Re: Review of the UMETCO Minerals Corporation's (Umetco's) ACL Application, TFN 3 1/258

WDEQ/LQD Technical Review Comments
Application for Alternate Concentrations Limits
Umetco - TFN 3 1/258 - April 2000

TO: Mark Moxley, District II Supervisor
FROM: Roberta N. Hoy, Geohydrologist *RNH*
DATE: April 10, 2000
RE: Review of Umetco ACL Application - TFN 3 1/258

FIGURE 2

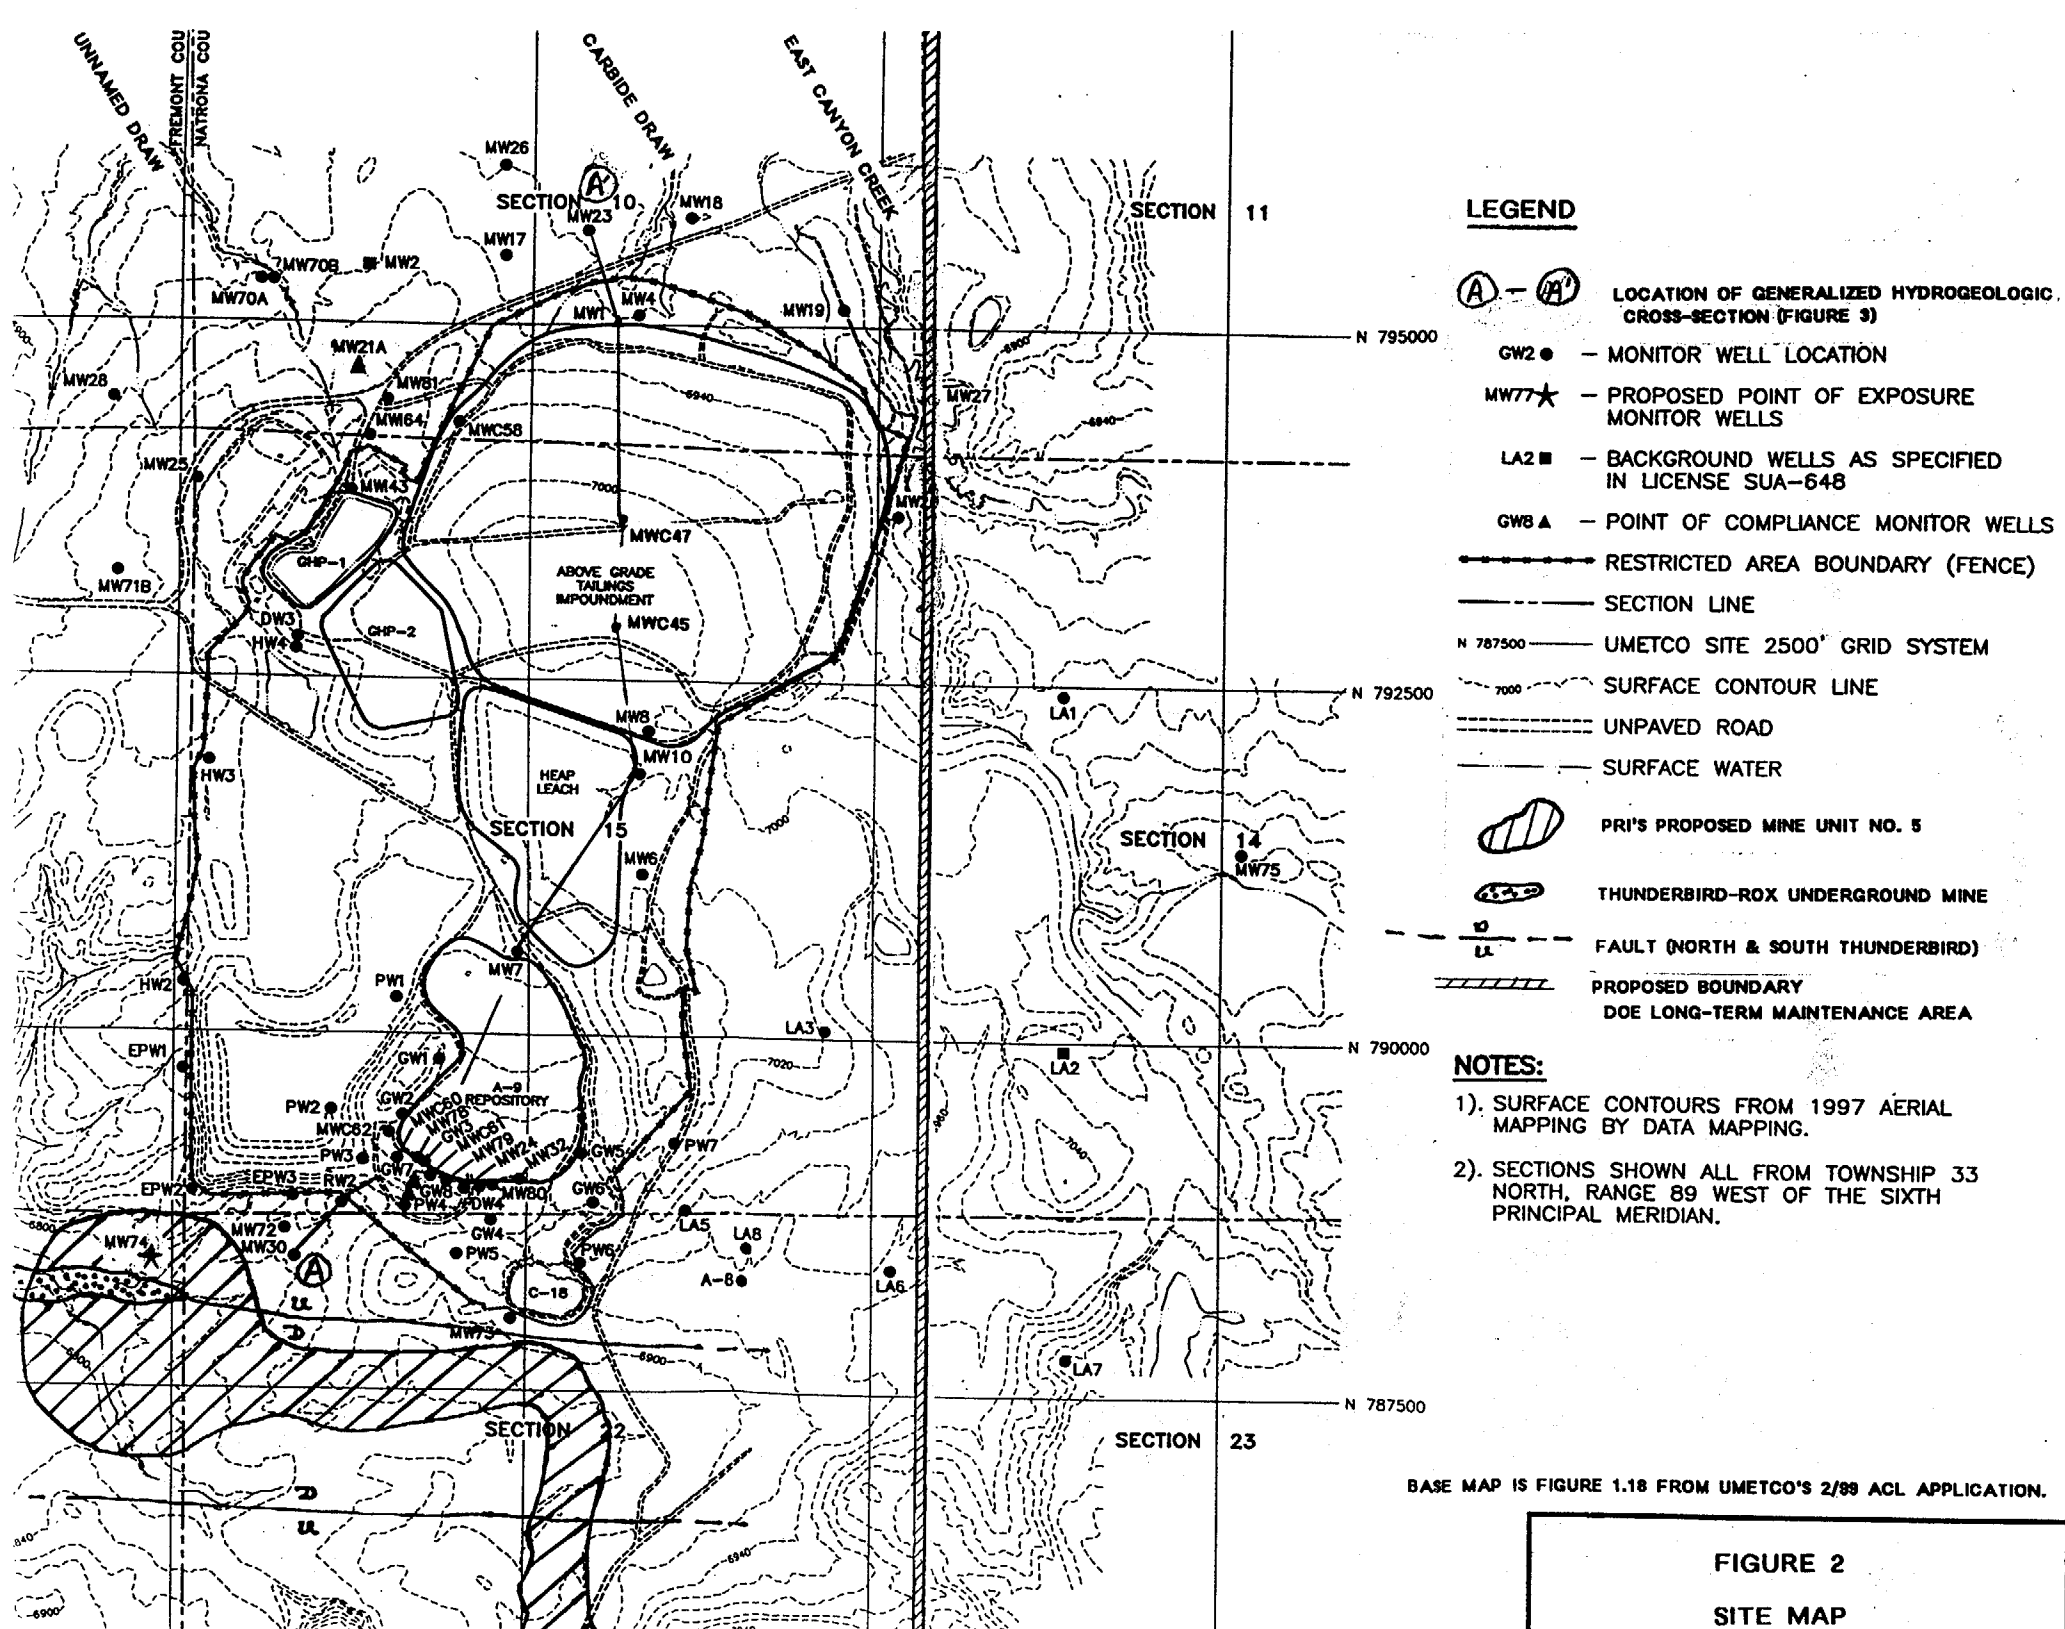
3.1 History of Tailings Disposal & Remediation Efforts, & Heap Leach Operations. Three areas at Umetco's Gas Hills Site were used for tailings disposal: (1) the Above Ground Tailings Impoundment (AGTI); (2) the A-9 Repository; and (3) the North and South Evaporation Ponds (Figure 2). The AGTI consists of a series of earth-filled dams used from 1960 until 1979 (Figure 2). The A-9 Pit was mined out prior to 1979, and the A-9 Repository was constructed by placing a 3-foot compacted clay layer in the pit. From 1979 through 1984, tailings were disposed of in the A-9 Repository, and liquids were decanted from this area to the North and South Evaporation Ponds. In 1988, tailings from the Riverton UMTRCA Title I site were disposed of in the A-9 Repository, and wastes from in-situ uranium mines and from the Gas Hills mine and mill site were also placed in the A-9 Repository. The clay-lined North and South Evaporation ponds were used for liquids decanted from the A-9 repository and for ground water pumped for control/remediation of the tailings leakage.

Three heap leach operations were also located close to the tailings disposal sites (Figure 2). These operations were in use from 1963-1967, 1973-78, and 1979-1987, respectively, and consisted of leach areas underlain by gravel and perforated pipe which was in turn underlain by a 1-foot layer of compacted clay.

The three drainages of concern, which extend north from the AGTI, are East Canyon Creek and two of its tributaries, Carbide Draw and an unnamed draw to the west of Carbide Draw (Figure 2). Comparison of sulfate concentrations in two wells along those drainages with sulfate concentrations in other wells in the vicinity indicates that the sulfate concentrations in those two wells are considerably higher than concentrations in other wells in the vicinity (Figure 6). In Well MW-20, along East Canyon Creek, sulfate concentrations are on the order of 3000 mg/l of sulfate, and in Well MW-70A, along the unnamed drainage, sulfate concentrations are on the order of 4000 to 4500 mg/l of sulfate (Figure 6). Leakage from the pond to the alluvial channel is known to have impacted conditions in the vicinity of Well MW-20 (Dames & Moore, Inc. "Evaluation of Ground Water Contamination - Existing Tailings Impoundment", prepared for Union Carbide Corp., June 1979). No similar evaluations were found for Carbide Draw or the unnamed drainage, although they may have been overlooked.

FIGURE 3
GENERALIZED
HYDROGEOLOGIC CROSS-SECTION
UMETCO GAS HILLS TAILINGS

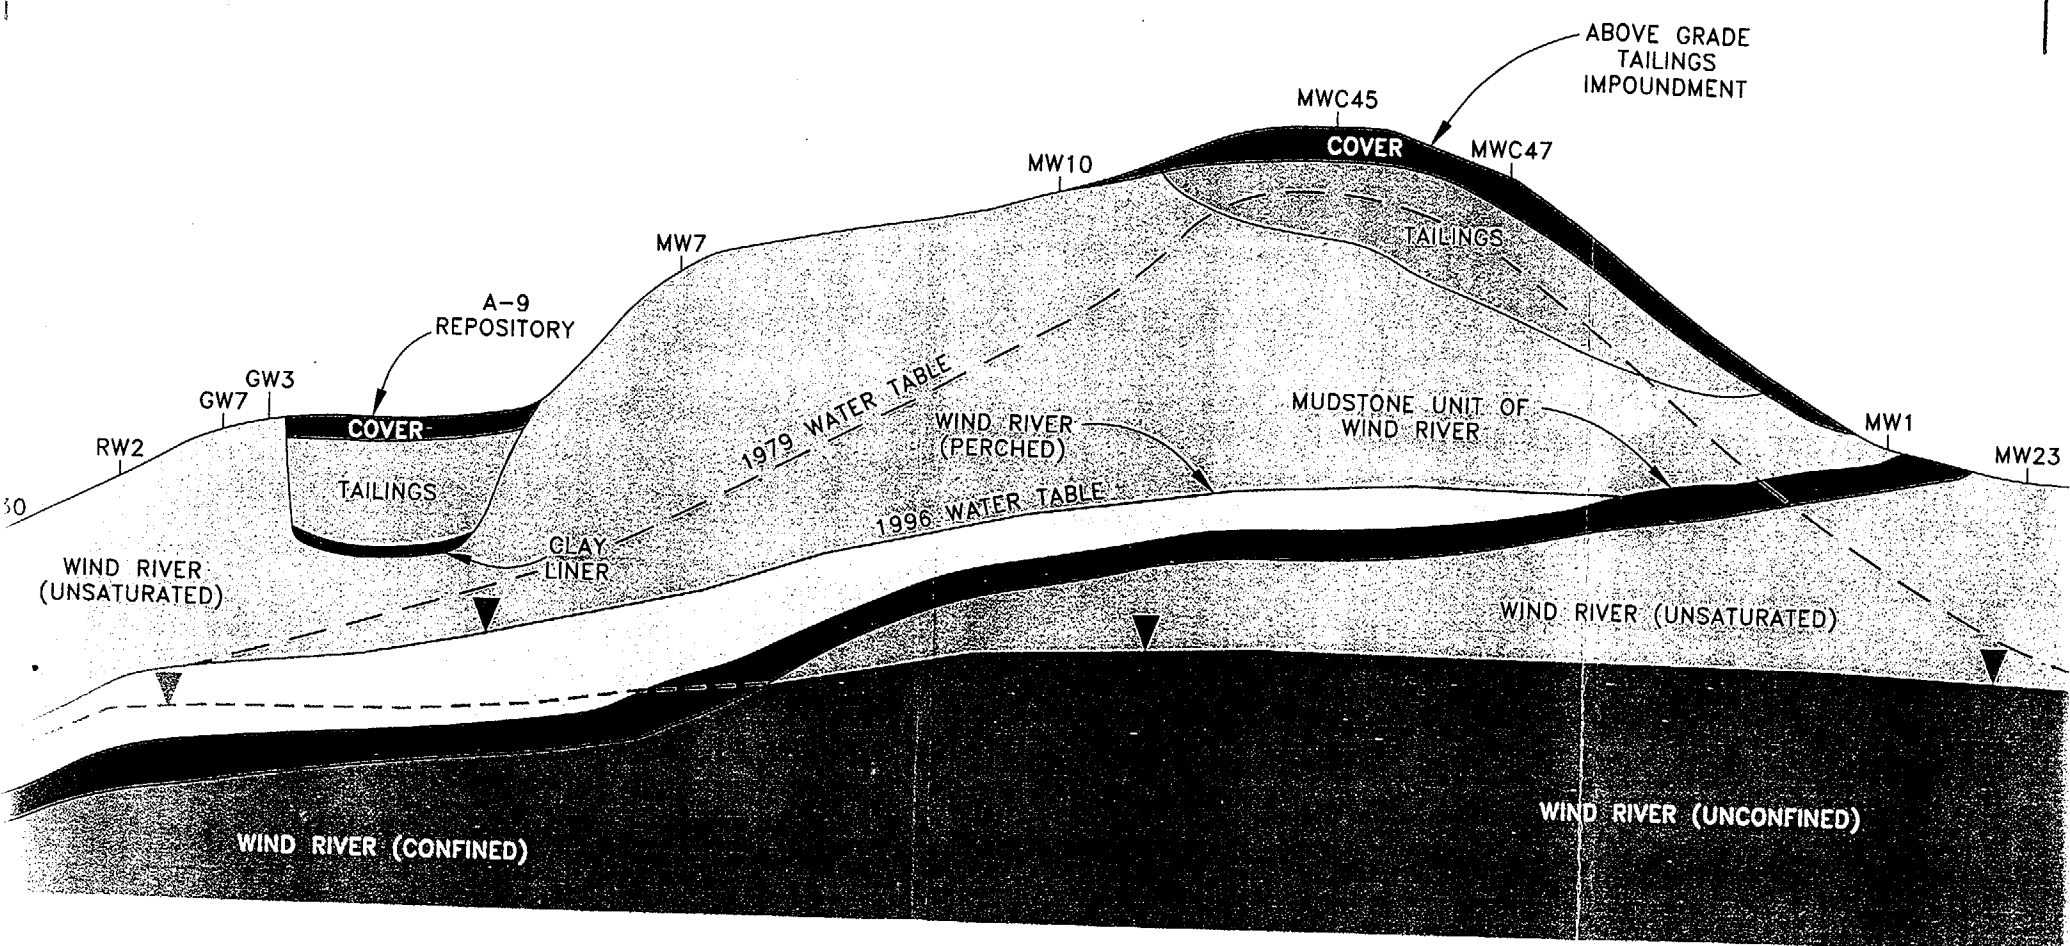
unconfined. Depending on ground water occurrence relative to the mudstone layer, the Lower Wind River Aquifer may be confined or unconfined. Figure 3 is a generalized north-south hydrogeologic cross-section through the Umetco site.
